Memo

To: The Atherton Planning Commission
From: Sally D Bentz-Dalton, Town Arborist
CC: Sung Kwon, Principal Planner
Date: 2/15/23
Re: Tree Protection Zone (TPZ) Exception 244 Park

Formal Application Request:

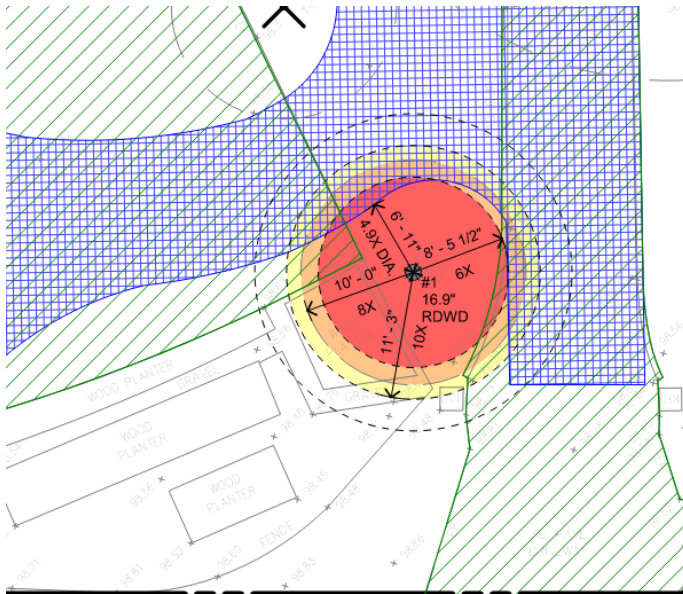
Request #1: 4.9x for driveway – tree #1
Request #2: 6x for an ADU, 8x for new residence, hardscape & bbq— Tree #12
Request #3: 6.5x shallow foundation – full basement 7.8x – tree #13
Request #4: 7.6x for a new ADU for tree #15
Request #5: 5.43x for a new residence for tree #16

Request #2: 6x for an ADU, 8x for new residence, hardscape & bbq- too close – Tree #12 - 30.3” dbh Redwood

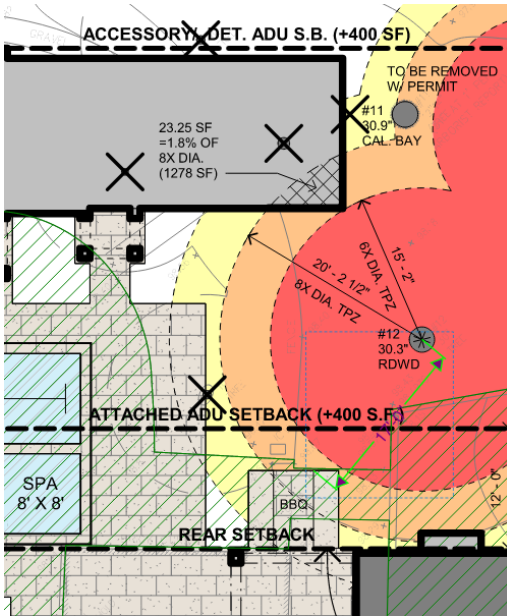
“We are requesting an exception to reduce the TPZ from 10X to 6X in one 23 SF area. The area of encroachment represents 1.8% of the 8x diameter TPZ for this tree, which could have otherwise been approved at staff level.”

It looks like the applicant is asking for a 6x TPZ for a proposed ADU and 8x TPZ for the new residence. There is also pool hardscape and a BBQ. More than 1 side of this tree has proposed development. The applicant must apply for the 8x TPZ staff exception for the new residence. The BBQ needs to 10x away or they need to apply for the 8x TPZ staff exception. I would recommend the hardscape be pulled back to allow more room for the tree.

I cannot recommend 6x for tree #12. There was no development in this area and the pool, bbq and new residence are encroaching on the tree as well. I can recommend 7x.

Request #2: 6x for an ADU, 8x for new residence, hardscape & bbq— Tree #12 – I cannot recommend 6x away. I can recommend 7x. Applicant must apply for staff exceptions for proposed residence and bbq. It is recommended that hardscape be pulled back too.

Request #2 – BBQ and hardscape are now relocated further from tree #12, ADU is also now 7X from tree #12

Request #3: 6.5x shallow foundation – full basement 7.8x – tree #13

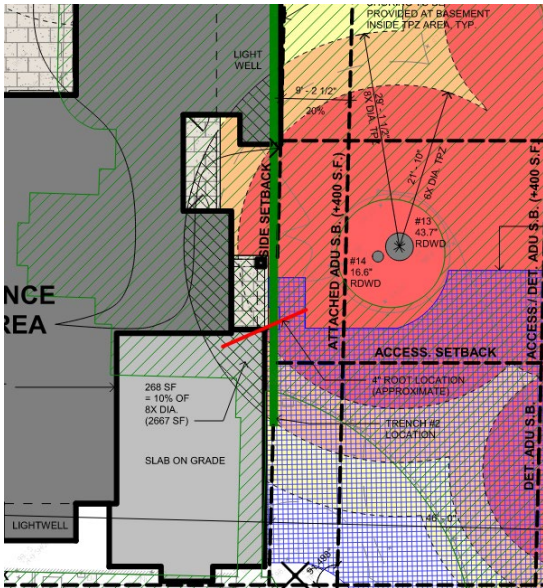
"We are requesting an exception to reduce the TPZ from 10X to 6.5X or 23' – 9 1/2" in one area of shallow foundation. The areas of full basement encroachment are further from the tree – 7.8X diameter minimum and will have stitch pier shoring to decrease construction impact on surrounding trees. - We are encroaching into the 8X TPZ of this tree a total of 82.4 SF which represents 3.1% of 8X diameter TPZ of the tree. - We did an exploratory trench along the edge of this tree and found only (1) 4" root (shown in bold red line on TPZ-2) which will be impacted by our planned construction. Our project Arborist confirms that there is minimal concern with cutting a 4" root on a redwood at the distance required. In our case, the root would need to be cut at 7.5X tree diameter or 27' – 1 1/2". - We have moved the structure 5.5ft further away from this tree given the root finding - We are eliminating most of the existing hardscape surrounding the tree (green diagonal striping) and only providing new driveway to the extent shown in blue cross hatch on diagram TPZ-2 - No other roots were found in our trench which continues at 24"-30" depth all the way to the extent of the lightwell shown in our diagram TPZ-2."

The applicant is requesting the stitch piers will be at 7.8x away from tree #13. The closest is 28'-3". They found 1 root at 7.5x away that will need to be cut. One root at that distance should be fine to cut. Because the tree has good tolerance and the piers are just under the 8x by 82.4 SF I can recommend the 7.8x away.

Request #3: 6.5x shallow foundation – full basement 7.8x – tree #13 – I can recommend the 7.8x.

Request #3 – No changes needed at tree #13 – 7.8x

Request #4: 7.6x for a new ADU for tree #15

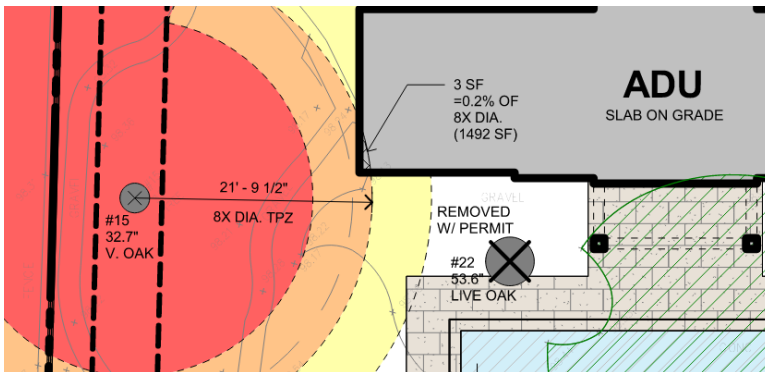
#15 Valley Oak – 32.7" diameter - We are requesting an exception to reduce the TPZ from 10X to 7.6X or 20'-9" in one small, 3 SF area. This encroachment is slightly smaller than the staff level approval of 8X diameter so we are requesting the planning commission to approve the encroachment. The area of encroachment represents 0.2% of the 8X diameter TPZ for this tree, which could have otherwise been approved at staff level.

- The adjacent structure is a slab on grade ADU, so the structural slab will have a very shallow depth as compared to a full basement excavation at areas of the Main House.

Valley Oaks have moderate tolerance to construction impacts, which would be 8x. Since the ADU is on slab and is only .2% down from 8x I can recommend the 7.6X TPZ.

Request #4: 7.6x for a new ADU for tree #15 – I can recommend 7.6x.

Request #4 – No changes needed at tree #15 – 7.6x

Request #5: 5.43x for a new residence for tree #16

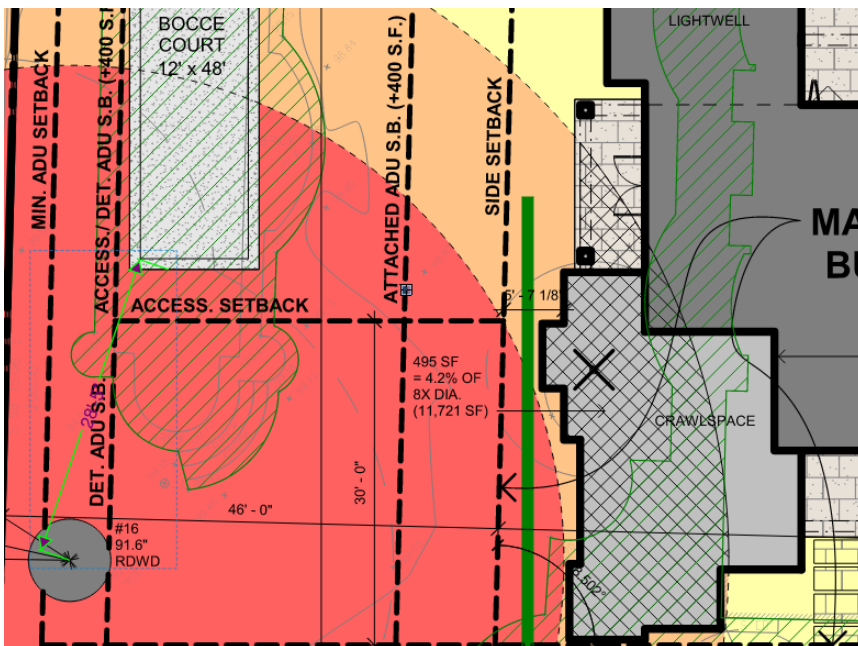
We are requesting an exception to reduce the TPZ from 10X to 5.43X or 40'-9 1/2". We are encroaching into the 6X TPZ a total of 111 SF which represents 1.7% of 6X diameter TPZ of the tree. We are asking for this encroachment because we did not find any substantial sized roots in trench #1. The tree is 91.6" in diameter which results in an excessively large TPZ based on the Town's standard 10X diameter calculation.

- We are removing the existing in-ground pool shown in green hatch adjacent to this tree. The planned bocce court shown will be surface level, low impact and sit further from the tree than the current pool which we think will

help the overall continued health of the tree. - Take note that the area of house encroachment will not be full depth basement, only crawlspace as shown in light grey on our TPZ-2 diagram

The applicant is asking for 3x TPZ for the bocce court.

The applicant is asking for 5.43x TPZ for the new residence with a crawl space and no basement in that area.

The applicant trenched the area at the green line below and no roots were found.

There is an existing pool where the bocce court will be placed. The applicant moved the bocce court back. Because they are improving the area for the tree with filling in the pool and moving the court back, I can recommend the 3x for the bocce court.

The current house is 60' away or approximately 8x away. The applicant is asking to place the house 40' 9.5" away. This tree is very large. The applicant is proposing only a crawl space and they moved the house further away from tree #13.

Request #5: 5.43x for a new residence for tree #16 – I can recommend bocce at 3x. I can recommend proposed house at 5.43x because they moved the house away from tree #13, they are only constructing a crawl space underneath and the tree is 92” diameter so it really hinders the buildable area.

Request #5 – No changes needed at tree #16- 5.43x
